Product Change Notification

113319 - 00

Change Notification #: 113319 - 00
Change Title: Intel® Server System P4304XXSHCN, P4304XXSHDR, and P4304BTLSHCNR PCN 113319-00, Product Design Update the Pedestal Chassis Hot Swap Drive Kit FUP4X35HSDK
Date of Publication: October 17, 2014

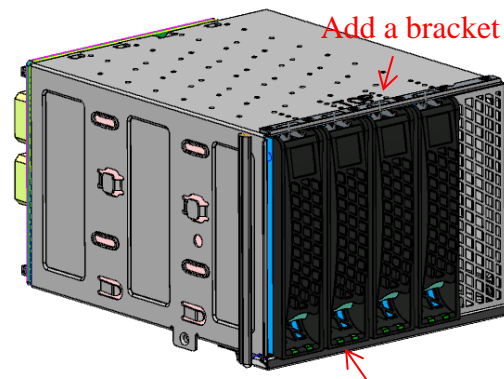
- Add a bracket and remove the venting holes for the Pedestal Chassis Hot Swap Drive Kit FUP4X35HSDK to improve the integration stability. Refer to the following pictures.

Remove the venting holes
